CITY OF WICHITA

Wichita-Sedgwick County Metropolitan Area Planning Department

Re: **BZA2010-00044: City Administrative Adjustment to reduce the number of parking spaces by up to 10 percent on property zoned LC Limited Commercial.**

Legal Description: Lots 83 -94, Block 7, Ohio Addition, Wichita, Sedgwick County, Kansas; generally located north of 13th Street North between Minneapolis Avenue and Minnesota Avenue.

SITE LAYOUT & UTILITY PLAN

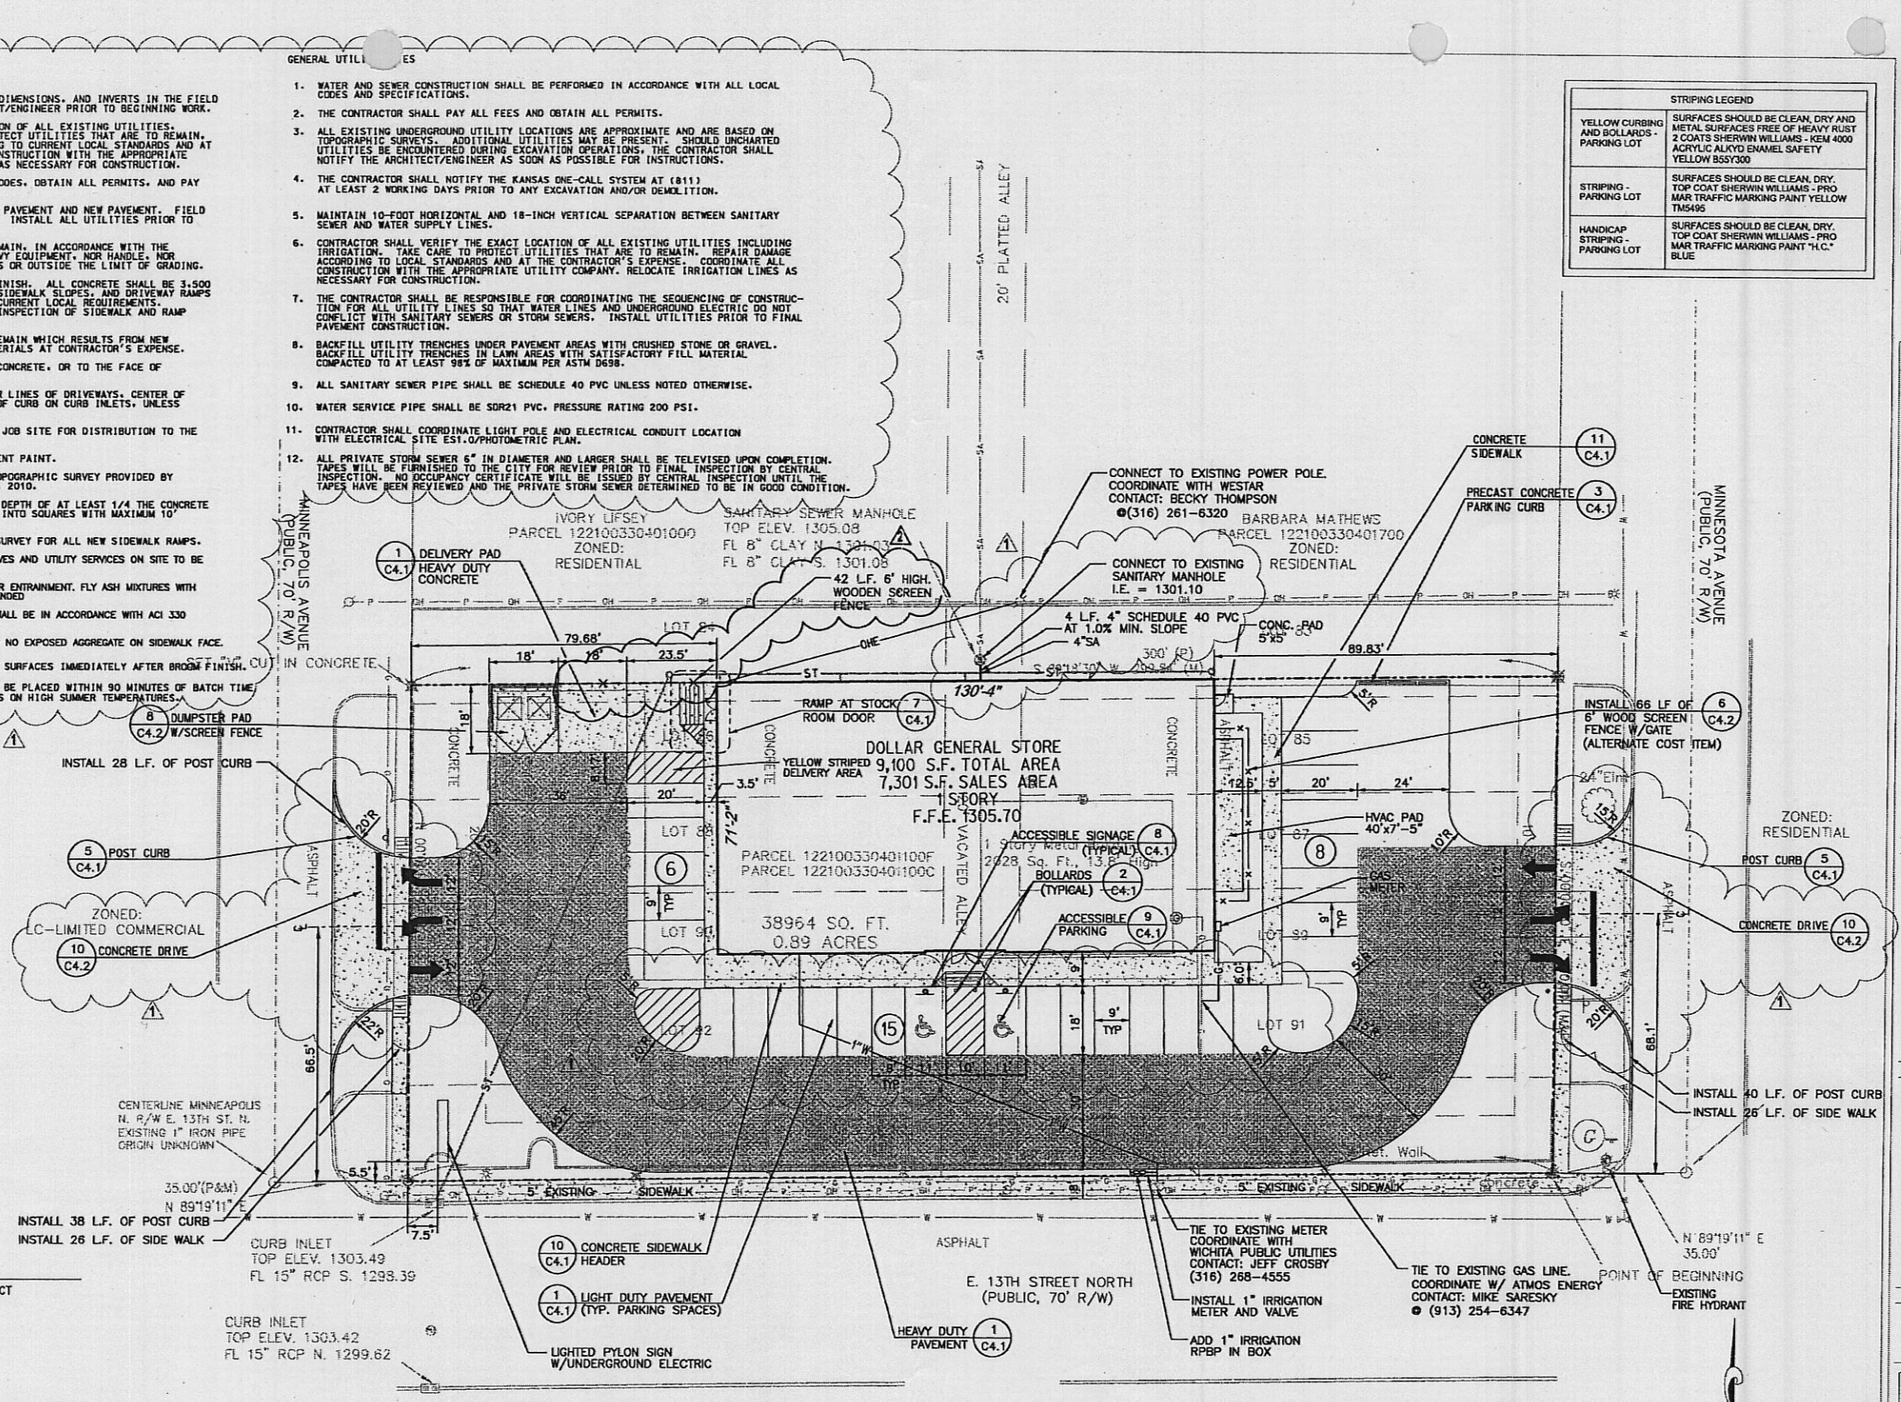
We have reviewed your request for an Administrative Adjustment to reduce parking requirements for the aforementioned property. You have stated that a new retail building is being constructed on the LC portion of the property (Lots 85-94) for the building, parking and landscaping. The northern 25-foot strip (Lots 83 and 84) is paved as an alley on property zoned B Multi-Family and will remain in this use. The site plan, utilized to its fullest, can provide up to 29 of the 31 parking space requirement.

1) Impact on safety and convenience of vehicular and pedestrian circulation: The 10 percent reduction will allow the maximum utilization of the site, without encroaching onto the right-of-way and providing required traffic circulation and drive aisle widths, and will preserve the private alley on Lots 83 and 84 for internal circulation. Therefore, it should not impact the safety and convenience of vehicular and pedestrian circulation.

2) Impact on existing uses in surrounding areas: Sufficient parking should be provided on site to meet the parking needs of the business. Additional on-street parking along Minneapolis Street, buffered by LC zoning on both sides of the street, offers as many parallel parking spaces as on-site

parking spaces eliminated by the adjustment. The redevelopment of the site should be a positive impact on the nearby commercial corridor, and the landscaping provided, to the extent possible, will enhance the overall appearance of the corridor. The Landscape Plan meets the Landscape Ordinance except for modification of parking lot screening opposite the building façade. The orientation of the vehicles is away from the street and separated by a drive aisle with a narrow strip of sod between the drive aisle and the sidewalk, thus reducing the prominence of the vehicles to traffic along 13th Street North, but separating the parking lot from the pedestrians. The clustering of well-landscaped corners of the lot will further reduce the prominence of the parked vehicles.

3) Compatibility with existing or permitted uses on abutting sites: The reduction in parking requirements is well within allowable adjustments. The proposed use is permitted by right by the LC zoning and keeps the 25-foot buffer alley to the north of the building.

4) Effect on public health, safety or welfare: There will be no encroachment into public utility easements or right-of-way, therefore, there should not be a negative impact on the public health, safety or welfare nor will properties or improvements in the vicinity be materially injured.

Our signatures below indicate that an Administrative Adjustment to allow a reduction in the parking requirements by up to 10 percent for the aforementioned property is hereby granted, subject to the following conditions:

1) The site shall be developed in general conformance with the approved site plan and Landscape Plan, and the Landscape Plan is approved as meeting the spirit and intent of the Landscape Ordinance for the partial waiver of parking lot screening along 13th Street North.

2) The parking area shall be paved and marked in accordance with the site plan.
